SAN FRANCISCO PLANNING DEPARTMENT

MEMO

TO: **Architectural Review Committee (ARC) of the Historic Preservation Commission**

RE: Review and Comment for SFDPW Replacement of Public Toilets and Kiosks
Case No. 2017-009220PTACOA-02

Grove St & Larkin St: Civic Center

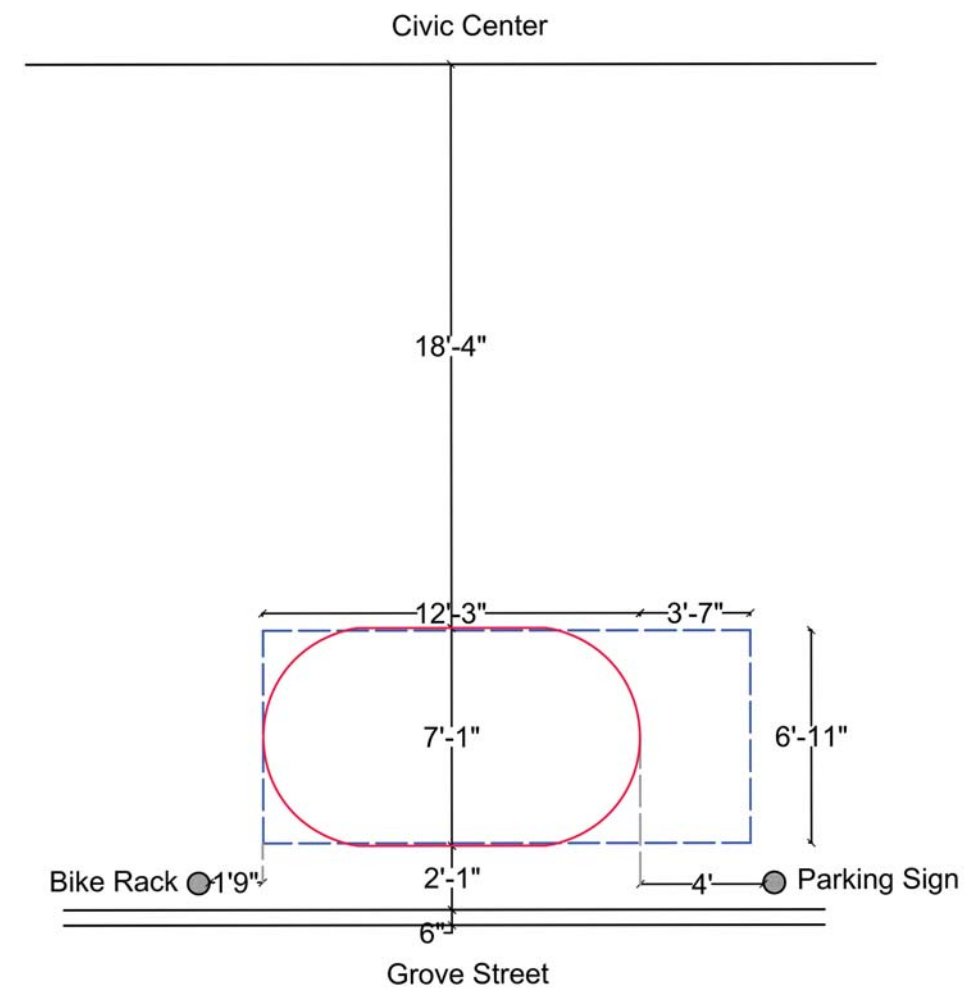
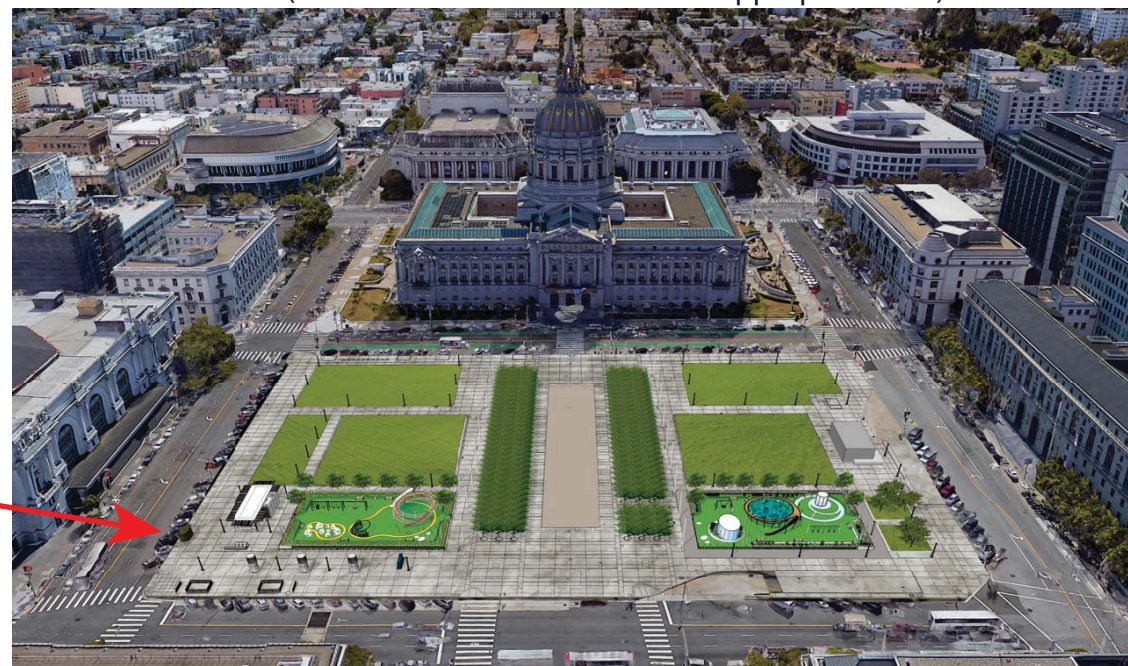
Civic Center: Staff is requesting review and comment from the ARC in regards to the proposed replacement and enlargement of the existing public toilet as it relates to the newly approved Civic Center Kiosk and the surrounding landmark district. The proposal includes an expansion in size of three existing single-stall public toilets into double-stall public toilets, resulting in an increase of approximately 4' in length and approximately 28 square feet in area in each location. The Grove & Larkin Streets location, within the Article 10 Civic Center Landmark District, is of concern due to the proximity of the recently approved Civic Center Kiosk adjacent to the existing public toilet. The Historic Preservation Commission approved the Civic Center Kiosk project per Motion No. 0313 on August 16, 2017. Copies of the plans have been included within the packet as Attachment #8.

Article 10, Proximal to Landmark, Cultural Landmark: 165

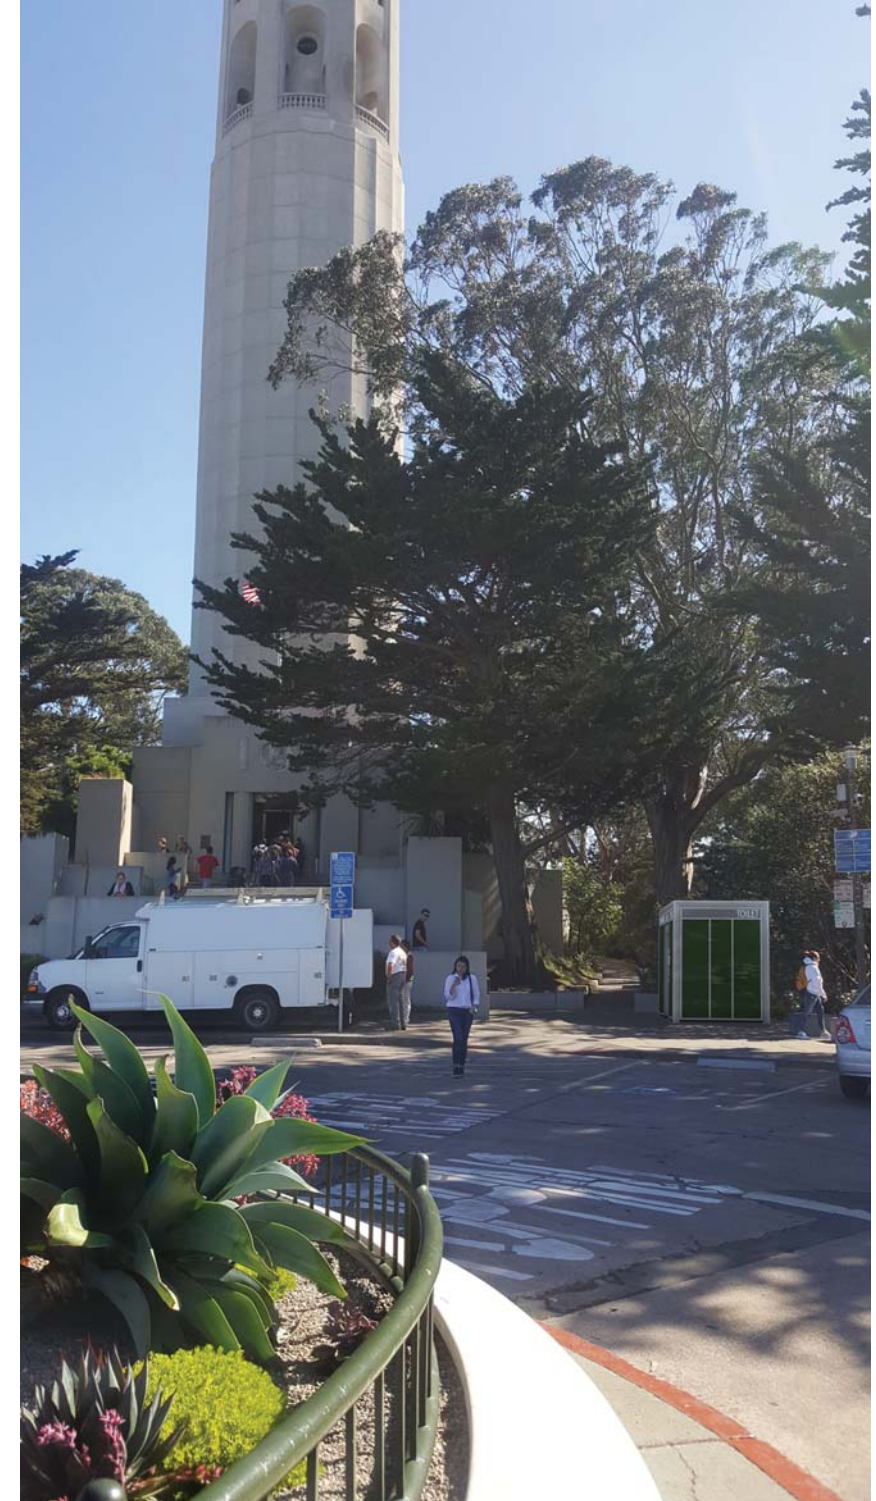
Coit Tower: Staff is requesting review and comment from the ARC in regards to the proximity of the proposed public toilet and its compatibility to Coit Tower in terms of shape and design. The project includes proposed replacement of the existing rounded shape, single-stall public toilet with a new rectangular shape, single-stall public toilet in the same location, resulting in a minimal increase limited to the outer corners of the structure. The existing public toilet is located directly northwest of Coit Tower, adjacent to the front steps. The Department received public correspondence from the Telegraph Hill Dwellers (THD) expressing opposition to the new public toilet, specifically due to the larger scale, incompatibility of the new design with the architecture and setting of Coit Tower and Pioneer Park, and to the cumulative impact of numerous facilities, which THD believes should be consolidated and minimized. Copies of this public correspondence are included in this packet as Attachment #2. Staff would like to bring to the Commission's attention that the existing structures are bolted to the existing foundations with utility connections, including water, sewer, and electrical, and its relocation would require the installation of new foundation with new utility connections.

Washington Square Park

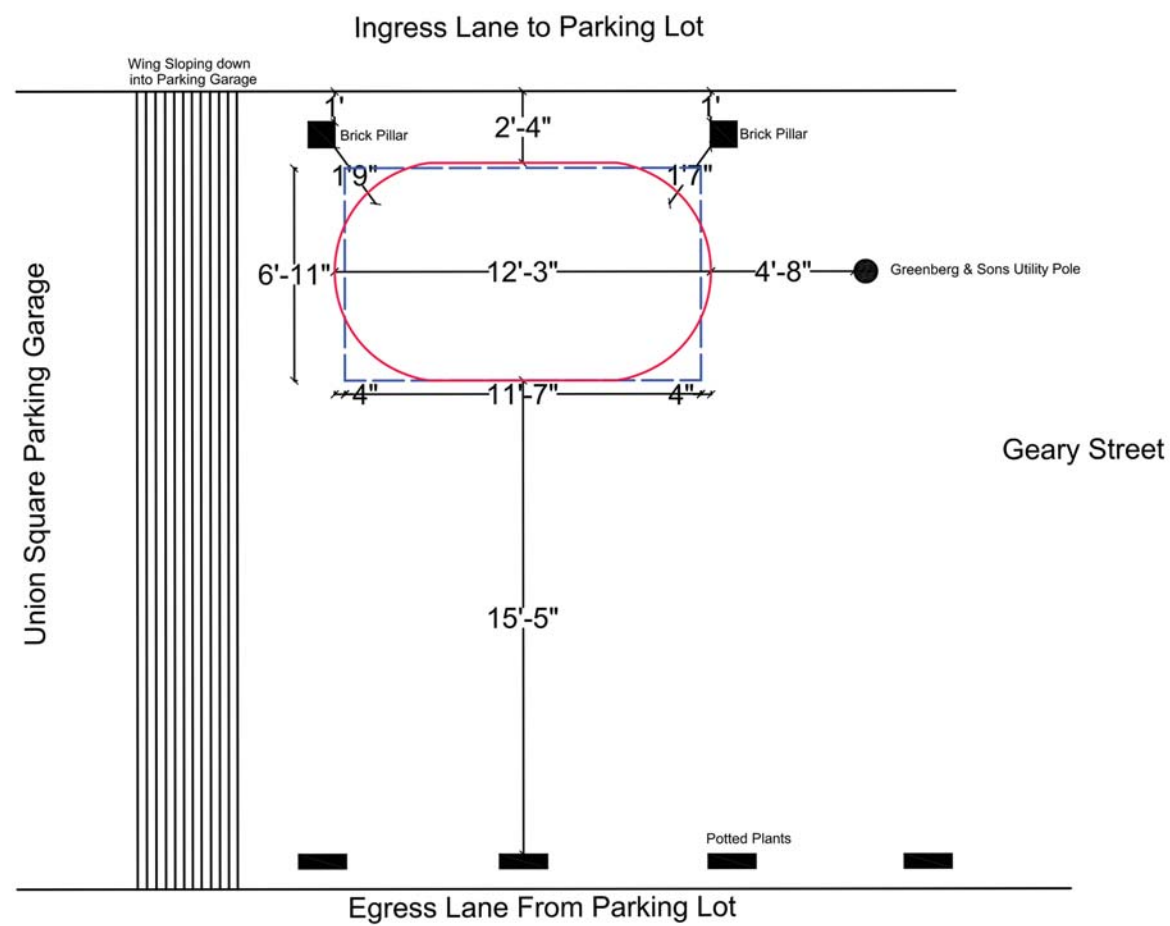
Washington Square Park: Staff is requesting review and comment from the ARC in regards to the proposed replacement public toilet as it relates to the newly constructed expanded convenience station and public toilet in the northwest corner of Washington Square Park. The project includes proposed replacement of the existing rounded shape, single-stall public toilet with a new rectangular shape, single-

stall public toilet in the same location, resulting in a minimal increase limited to the outer corners of the structure. The existing public toilet is located on the sidewalk directly south of the park, which is included in the boundaries of City Landmark No. 226 per the Designating Ordinance. Copies of the Designating Ordinance are included in this packet as Attachment #4. The Department received public correspondence from the Telegraph Hill Dwellers expressing opposition to the new public toilet and a desire to remove the existing public toilet, specifically due to the recent expansion of the existing convenience and public toilet station located at the northwest corner of the park. Copies of this public correspondence are included in this packet as Attachment #2. The existing facility included two stalls in the women's restroom and two stalls in the men's restroom, none of which were ADA accessible. The replacement facility includes three stalls in the women's restroom and three stalls in the men's restroom; one stall in each is now ADA accessible. The project resulted in an expansion that approximately doubled the square footage of the structure. The new replacement convenience and public restroom project was approved by the Historic Preservation Commission per Motion No. 0193 on April 3, 2013. Copies of the plans have been included in the packet as Attachment #5.

- **THD supports the removal of the JC Decaux toilet at Washington Square.**
In addition, THD's Board of Directors strongly supports removal of the existing Decaux toilet at Washington Square. Now that a new restroom facility has been constructed within Washington Square, it is past time for Decaux to remove its facility that now clutters the sidewalk and impairs views of Washington Square and Saints Peter and Paul Church.
- **THD urges the City to require the removal of JC Decaux newspaper racks.**
THD also urges DPW to require the removal of all newspaper racks from the sidewalks in North Beach. These racks are now empty eyesores used as receptacles for trash and rubbish, and should be removed from our sidewalks consistent with the City's policies to maintain and enhance the pedestrian environment.

Recommendation #6: The Department recommends the public toilet at Washington Square Park remains a single-stall toilet since the public toilets at the northwest corner of the park were recently expanded to add additional stalls.
